Contractor:  TIANCHEN CORP. CHINA	Project :	MKP Methanol Project			Owner :  شرکت کیمیای پارس خاورمیانه Middle East Kumiya Pars Co.
	Unit	General Technical	Phase	Detail Engineering	
	Doc. Title :	PACKAGE HAZOP			
Vendor :  新鼎信息技術(上海)有限公司 Advanced Control & Information Technologies Co., Ltd.	Owner No.	MKP-11-DE-9000-SF-RPT-001B			Rev. : 0
	Contr. No.:	MKP-11-DE-9000-SA01-RPT-001B			
	Vendor No.	16E2416A			Page : 1 of 25

PACKAGE HAZOP

Node 3006

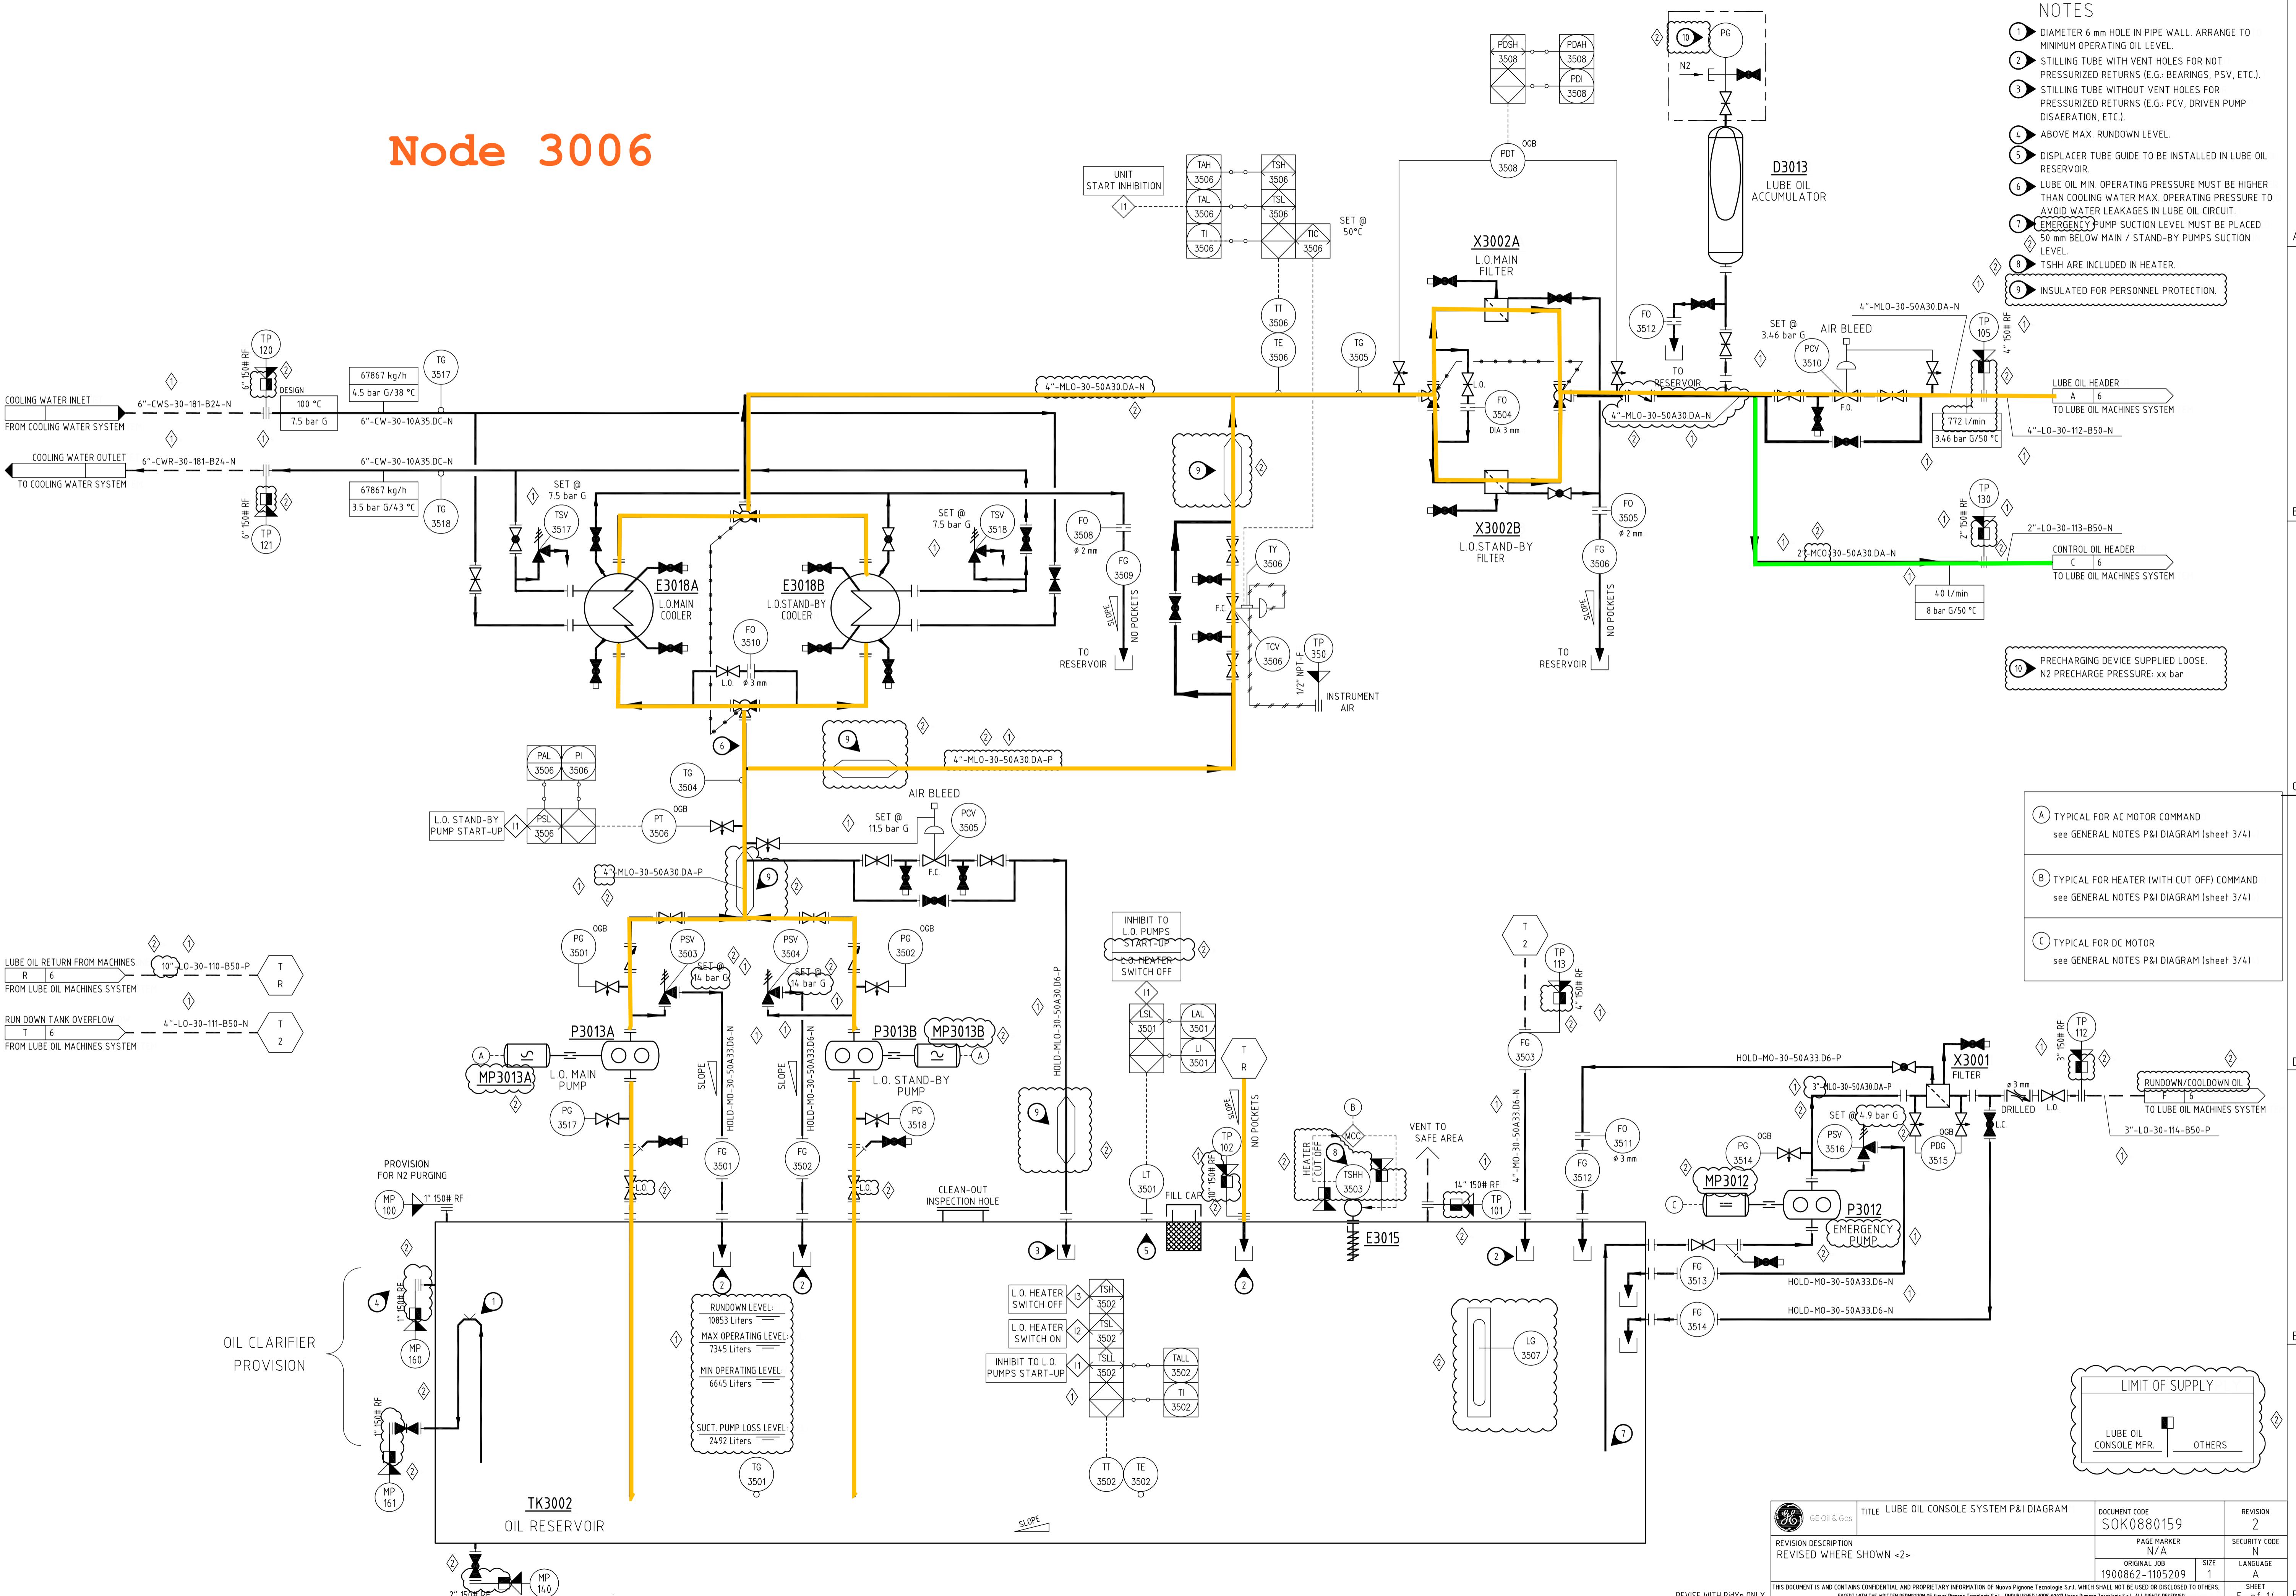
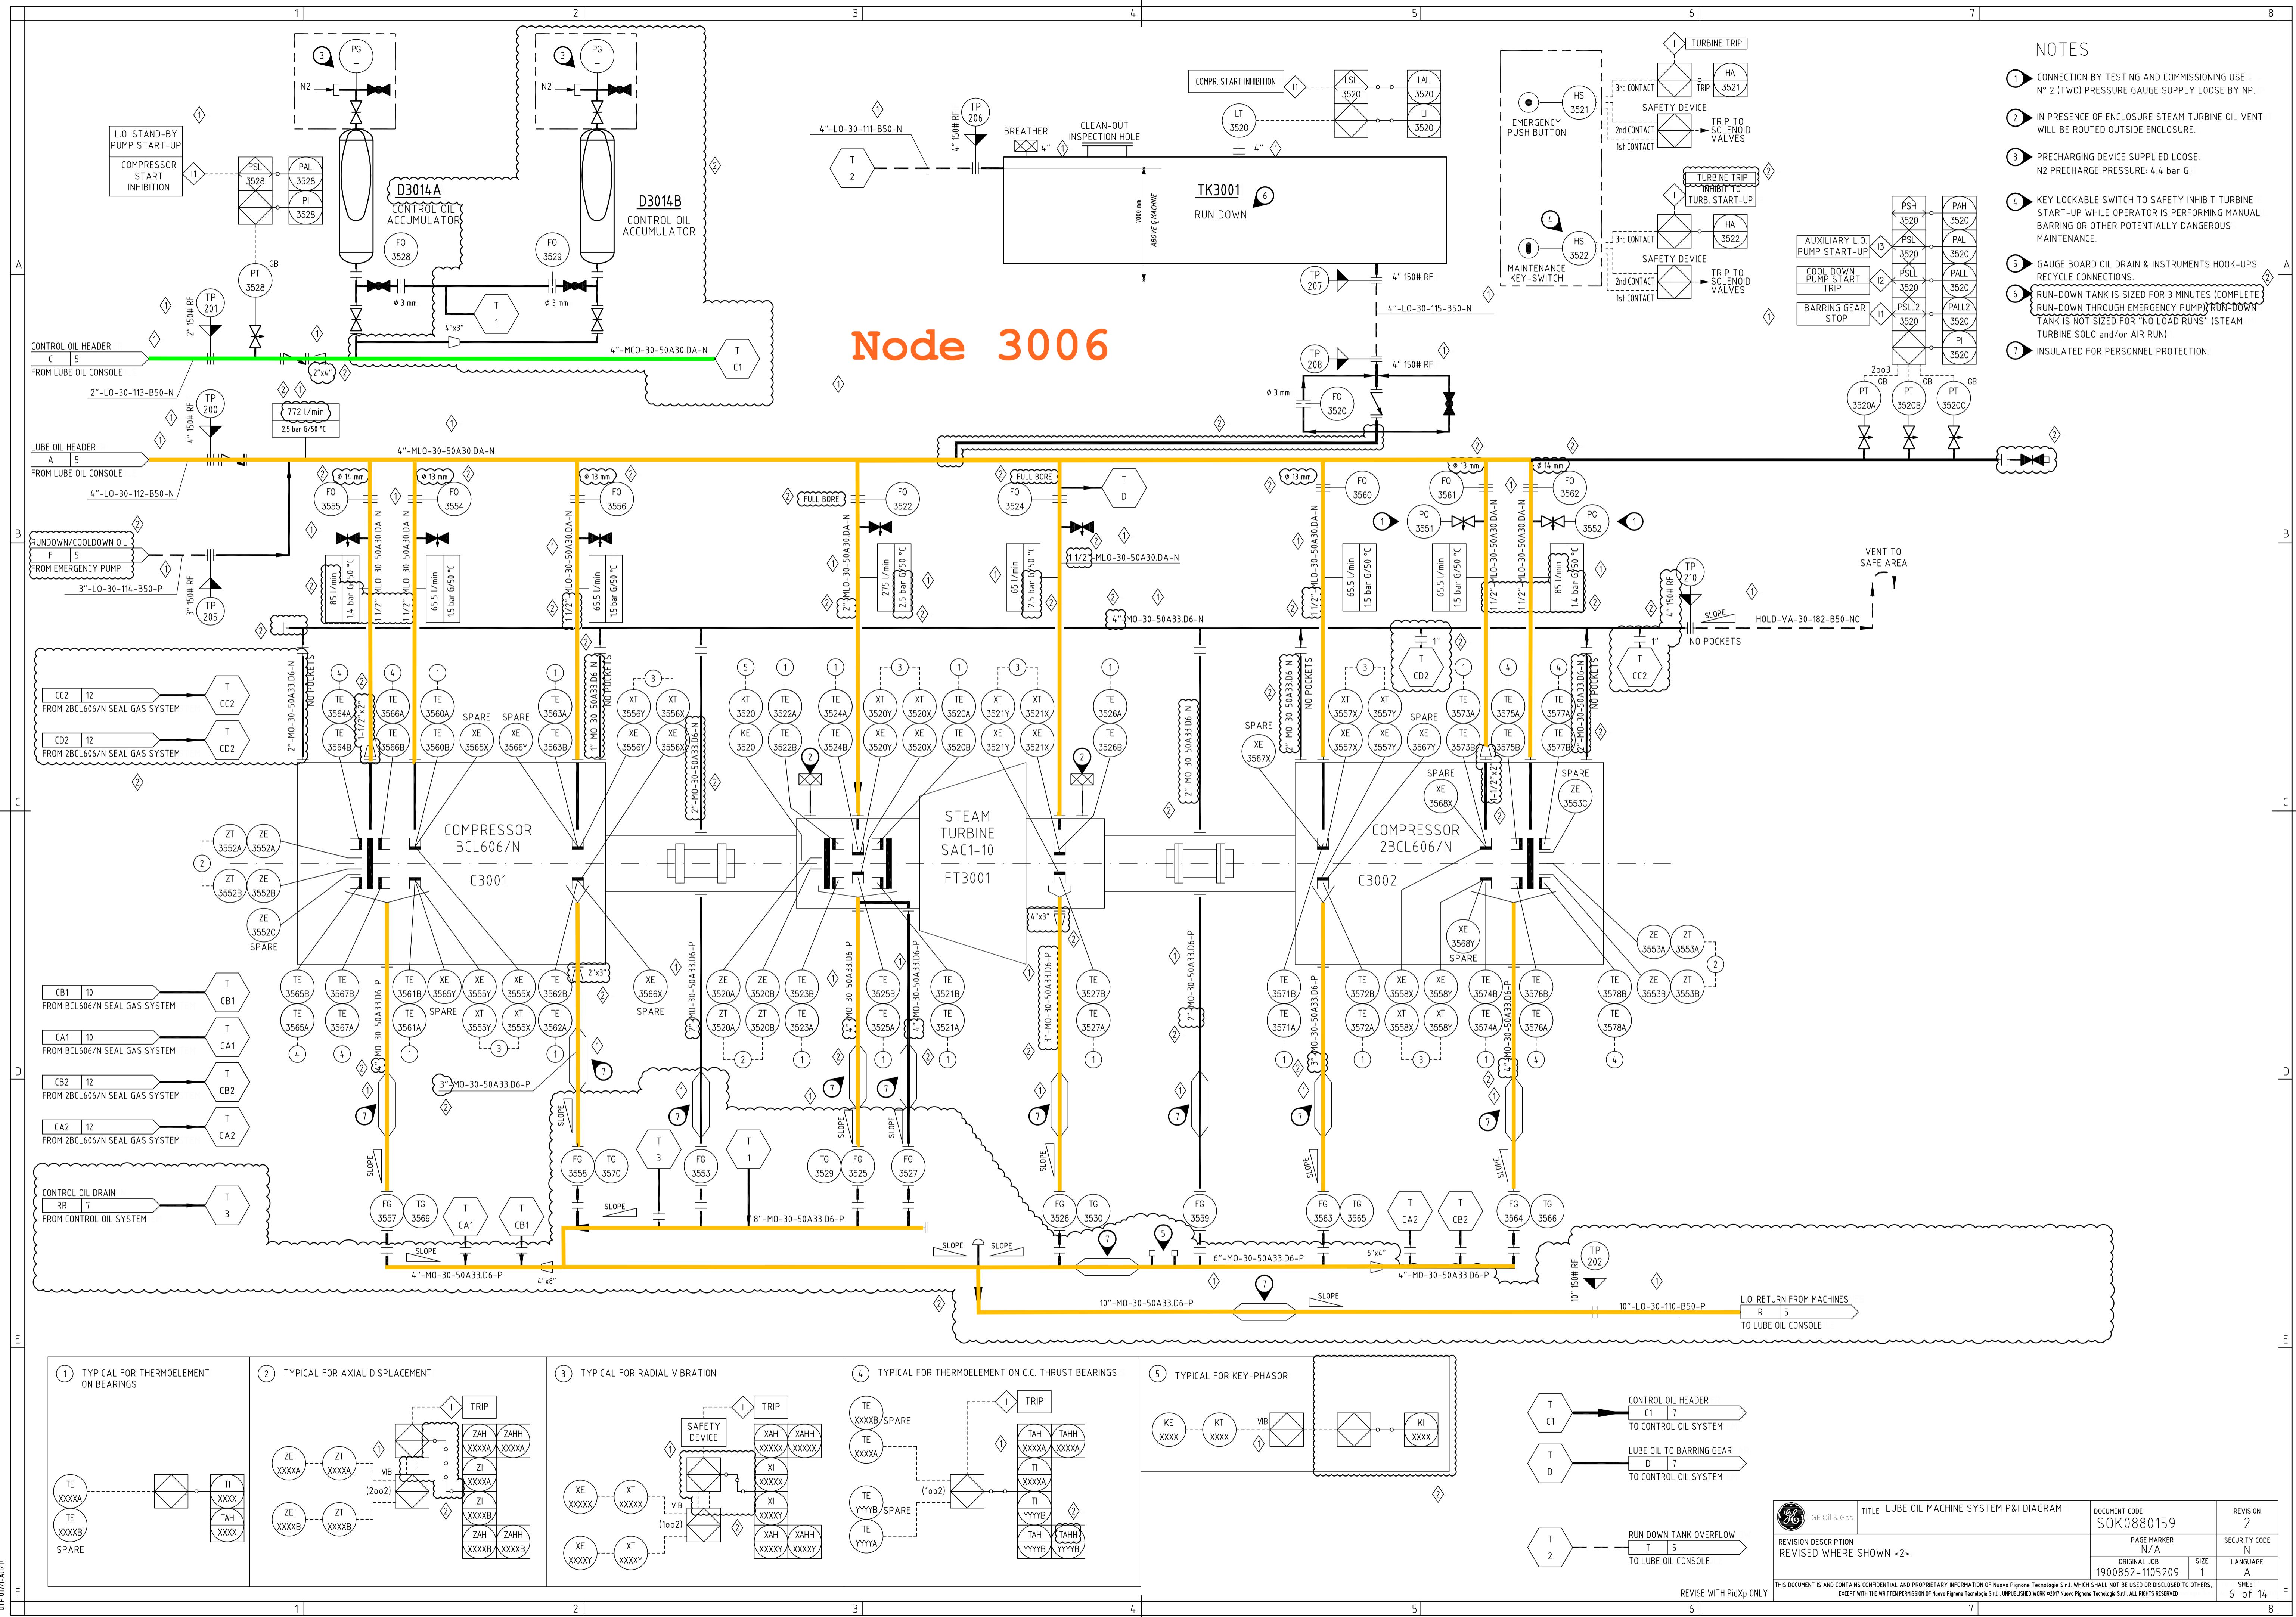
3006.14	3	Add high level alarm at pot of sub flare header of compressor house area 3000 and show this pot on P&ID no. 8500-PID-002.	Y			TCC
3006.19	3	Add high temperature alarm on TT-3744.	Y			GE
3006.21	3	Add high temp. alarm for TI-3722.	Y			GE
3006.24	3	to check the capacity of the breathing valve according to the max. gas blow.	Y			TCC
3006.26	3	to check the capacity of the breathing valve according to the max. gas blow.	Y			TCC
3006.32	3	GE provide the information about the oil quantity between the main pumps suction loss level and emergency pump suction loss level.	Y			GE
3006.47	2	Operation Procedure should be placed that stop the steam turbine and remove the vacuum from the condenser in case of loss of LP steam. (To be mentioned in GE operation manual of the compressor package, and incorporated in the plant operation manual.)	Y			GE
